ULNRC- 04558

**DOCKET NUMBER 50-483
CALLAWAY PLANT
UNION ELECTRIC COMPANY
RESPONSE TO REQUEST FOR ADDITIONAL INFORMATION
ON REVISION TO TECHNICAL SPECIFICATION 5.5.9
"STEAM GENERATOR (SG) TUBE SURVEILLANCE PROGRAM"**

**REQUEST FOR ADDITIONAL INFORMATION
REVIEW OF THE CALLAWAY PLANT APPLICATION
FOR REVISION TO TECHNICAL SPECIFICATION 3/4.4
TAC NUMBER: MB1214**

Figure R6-17. Crack A12: One and One Half Skip Reflection

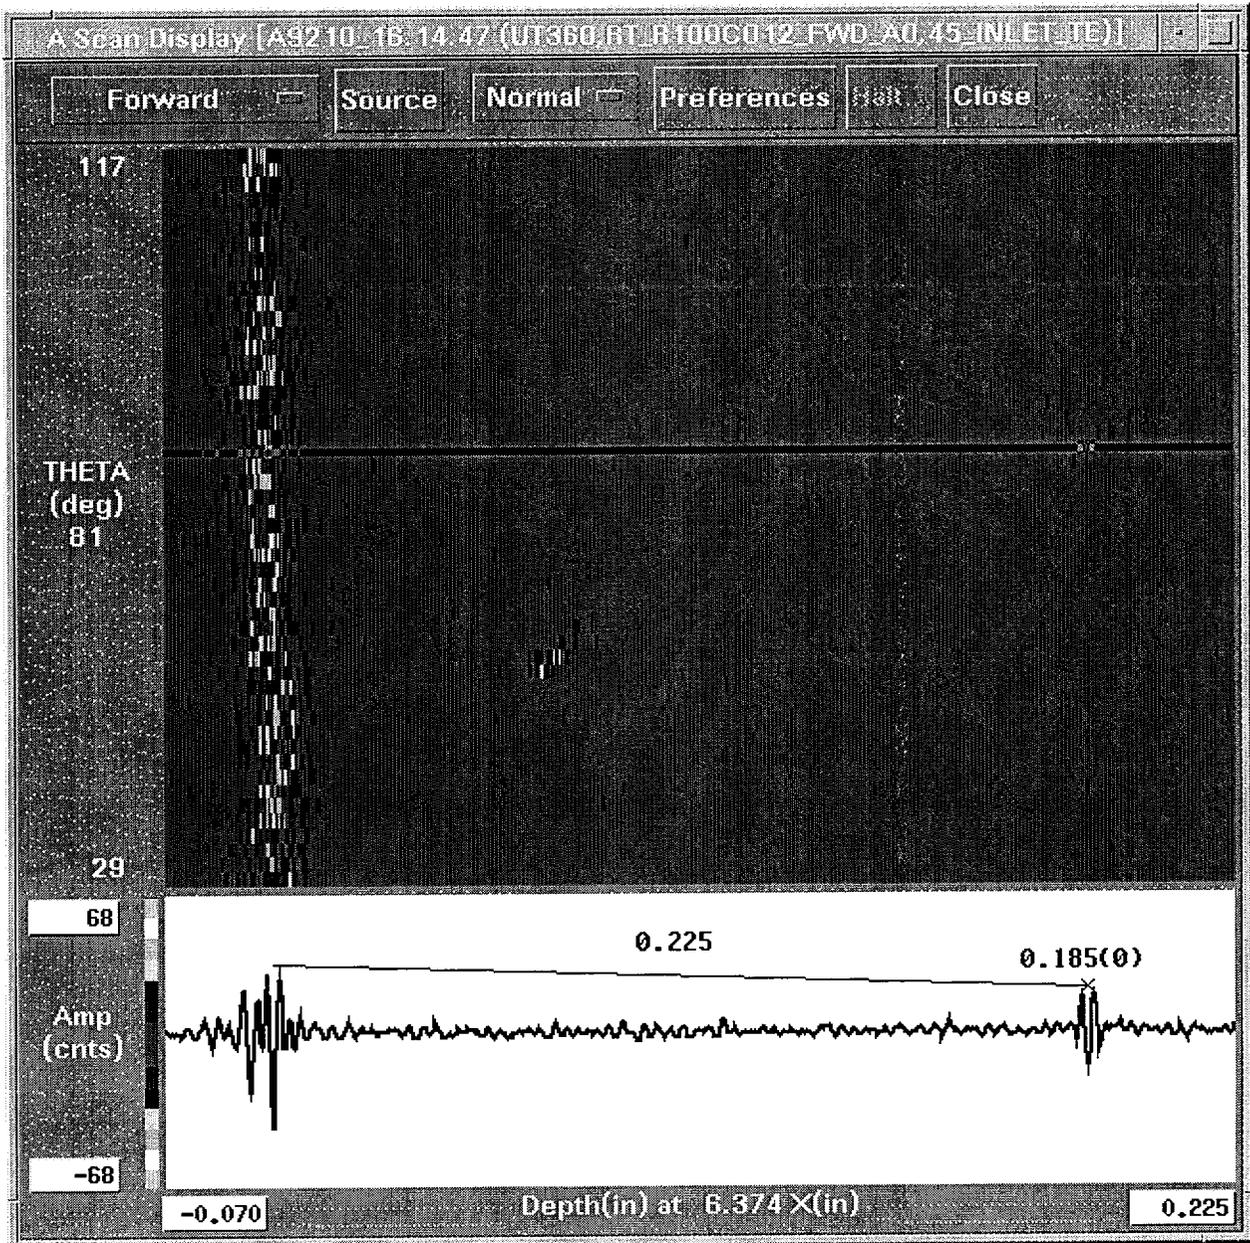
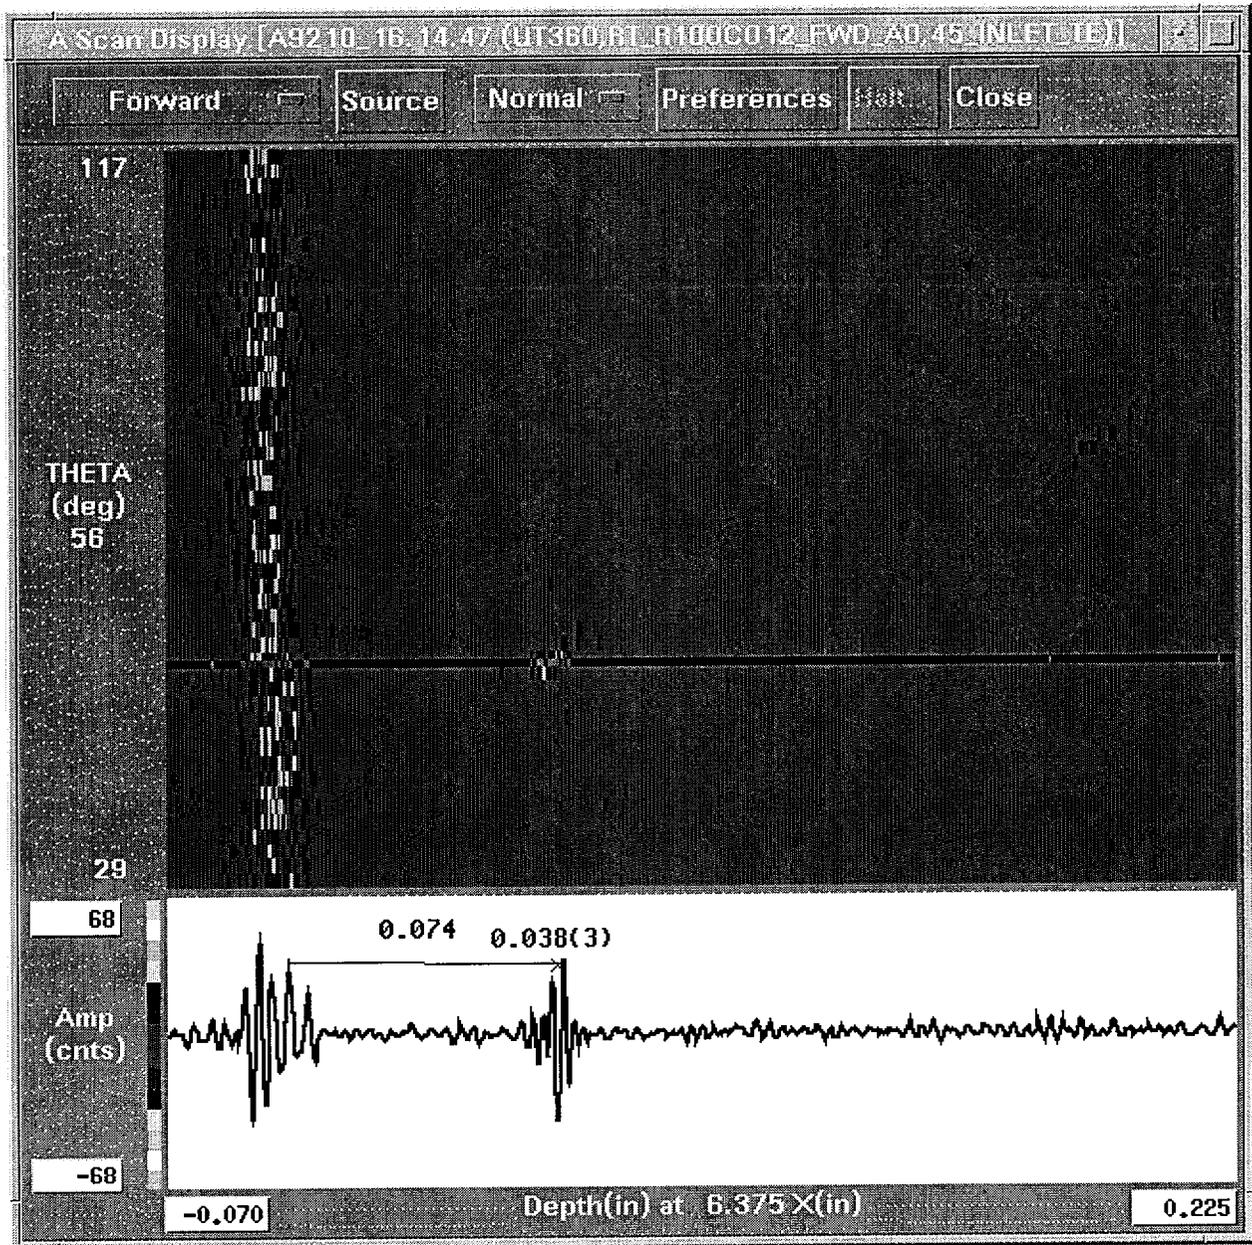
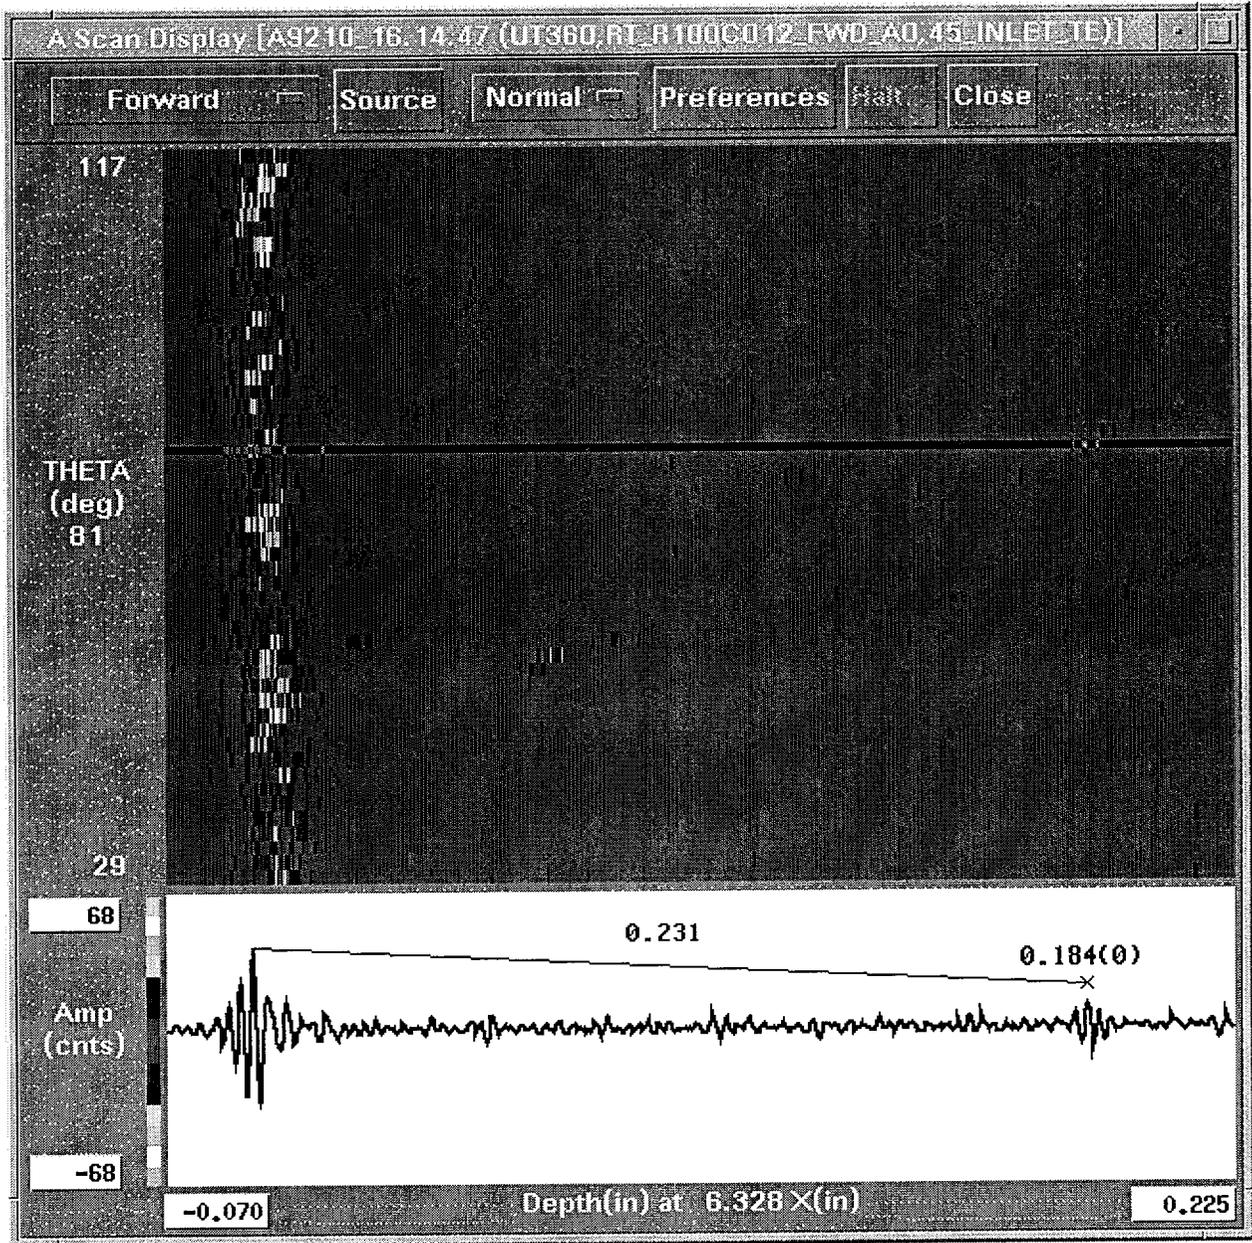
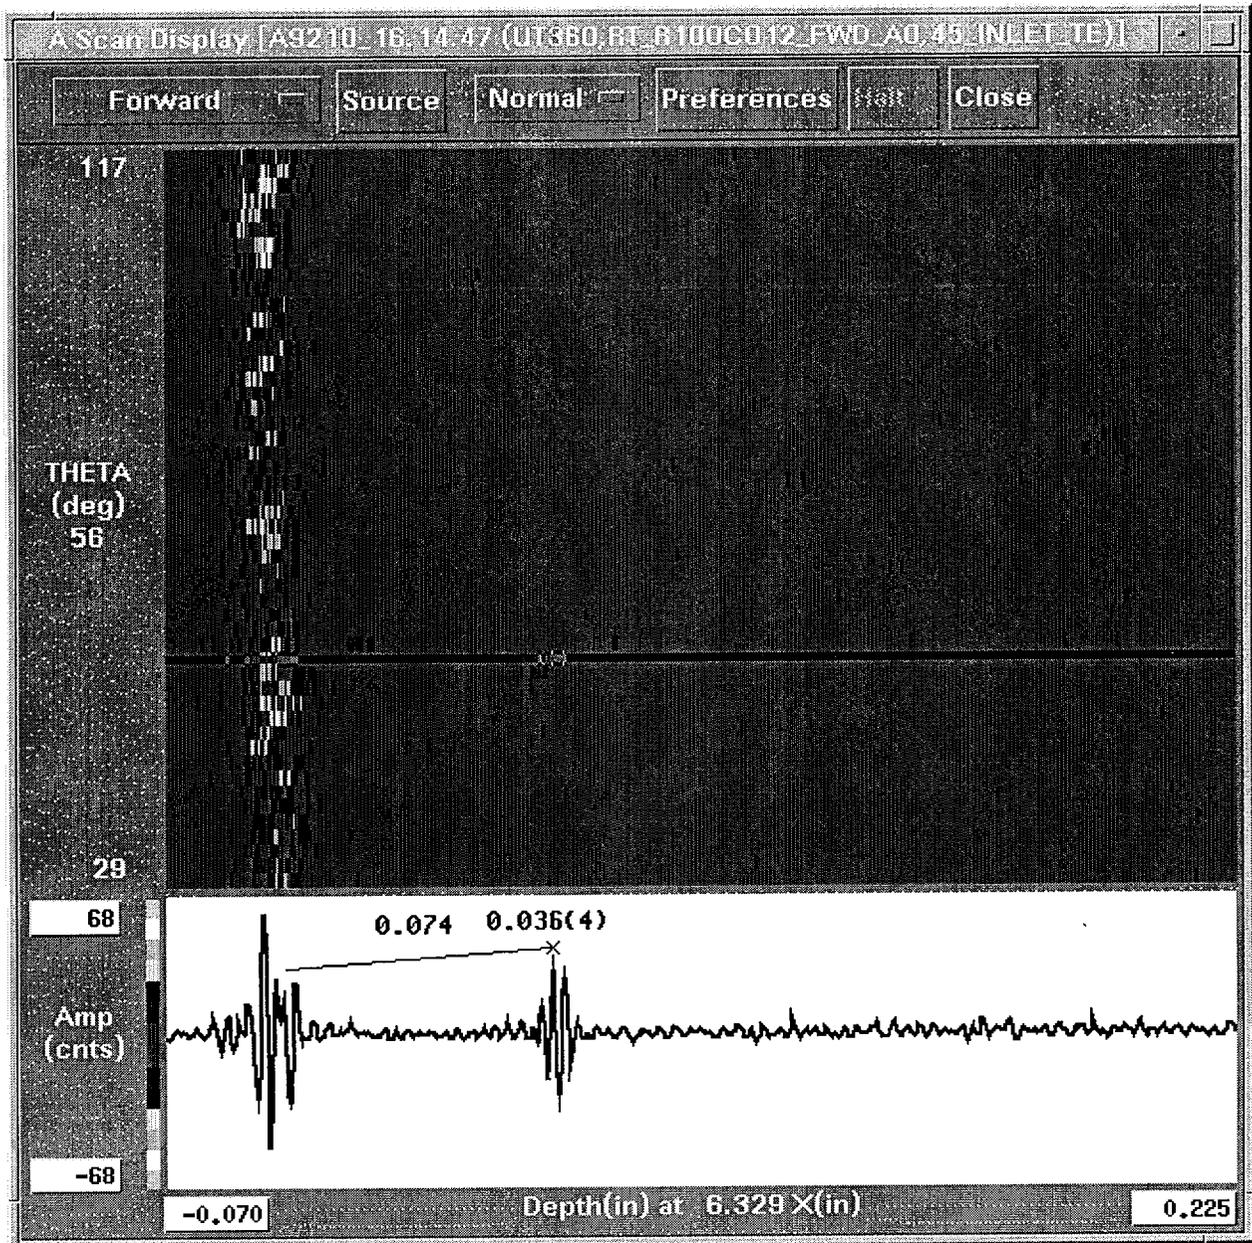
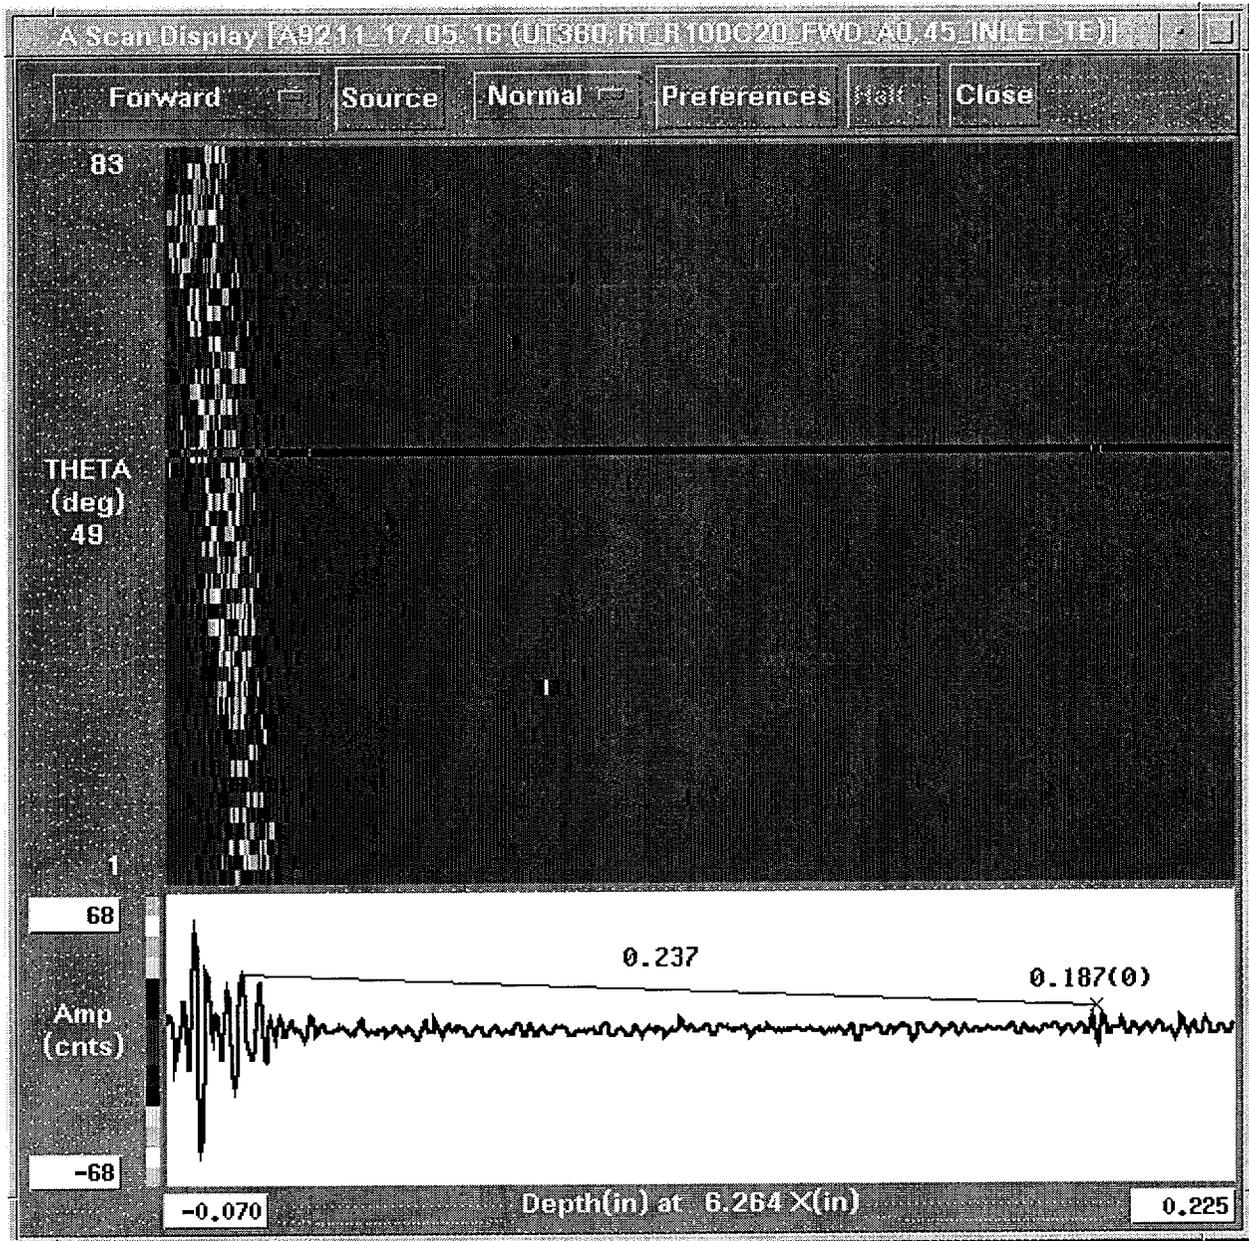
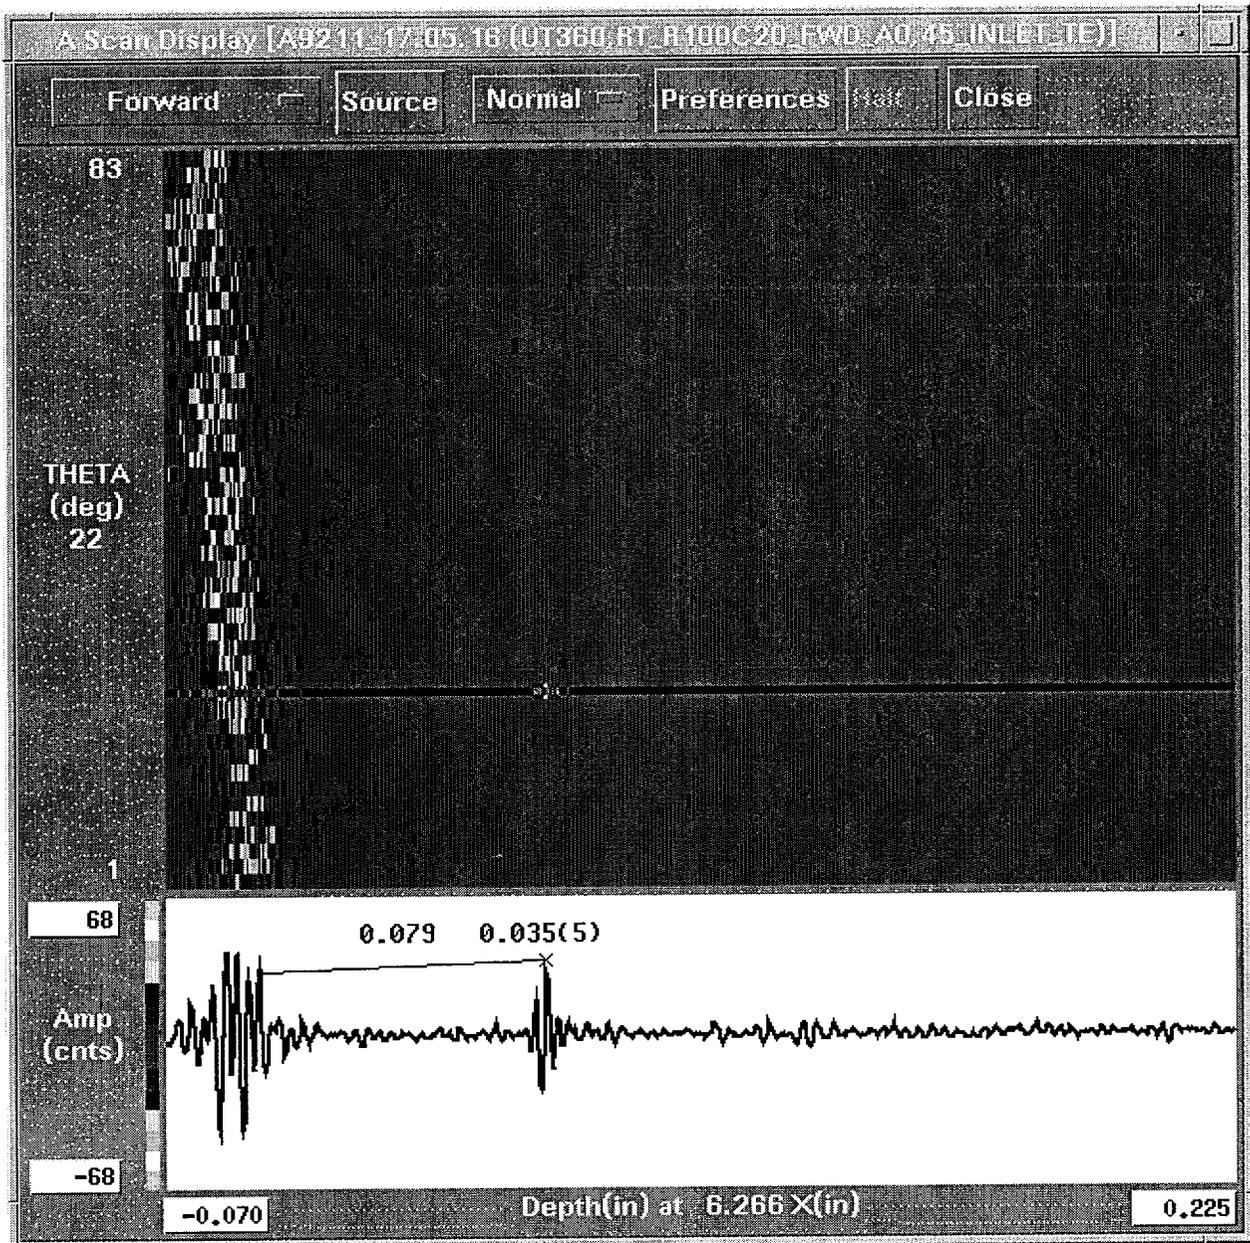
RAI # 6. During the meeting, FTI indicated that PWSCC detectability in the sleeve could be inferred from the ID notches in the UT calibration standards and the data sets containing pits. It is not clear to the staff how detecting EDM notches in the calibration standards or another degradation morphology such as pits would infer an ability to detect tight flaws such as PWSCC. Explain the basis for the statement that sleeve PWSCC ID defects will be detected, and the resulting sensitivity and POD, since the peer review (ETSS # 98404) only covers volumetric defects. Please provide additional discussion or, preferably, additional data to support the claims of the capability of the technique to detect PWSCC in the sleeve. (Question from the 6/7/01 meeting held with UE, FTI, and the NRC staff)

For crack A12, the UT measured combined wall thickness is 0.073 inch at the 6.3 and 6.4 inch axial locations. For crack A22, the UT measured combined wall thickness is 0.077 inch at the 5.9 and 6.1 inch axial locations and 0.080 inch at the 6.25 inch axial location. Both cracks are in the expansion transitions of their respective tubes. The expansion transition geometry did not adversely affect the detection of these cracks.

This is the one and one half skip reflection for crack A12 at the 6.374 inch axial location. The 0.185 inch depth (time of flight) and the 81 degree circumferential location will be used to qualify this reflection with the half skip reflection. The reflection depth from the surface, 0.225 inch, is nearly equal to the expected depth (three times the combined wall thickness) or $(0.073 * 3) = 0.219$ inch.

This is the half skip reflection for crack A12 at the 6.329 inch axial location. The delta depth is $(0.184 - 0.036) = 0.148$ inch. The delta displacement is $((81 - 56) * 0.006) = 0.150$ inch. Since these two results, (0.148 and 0.150), are within one pitch (0.015 inch), the half skip and the one and one-half skip have been correctly identified. The delta depth and delta displacement are also nearly equal to the expected value of two times the wall thickness.

This is the one and one half skip reflection for crack A22 at the 6.264 inch axial location. The 0.187 inch depth (time of flight) and the 49 degree circumferential location will be used to qualify this reflection with the half skip reflection.

This is the half skip reflection for crack A22 at the 6.266 inch axial location. The delta depth is $(0.187 - 0.035) = 0.152$ inch. The delta displacement is $((49 - 22) * 0.006) = 0.162$ inch. Since these two results, (0.152 and 0.162), are within one pitch (0.015 inch), the half skip and the one and one-half skip have been correctly identified. The delta depth and delta displacement are also nearly equal to the expected value of two times the wall thickness.
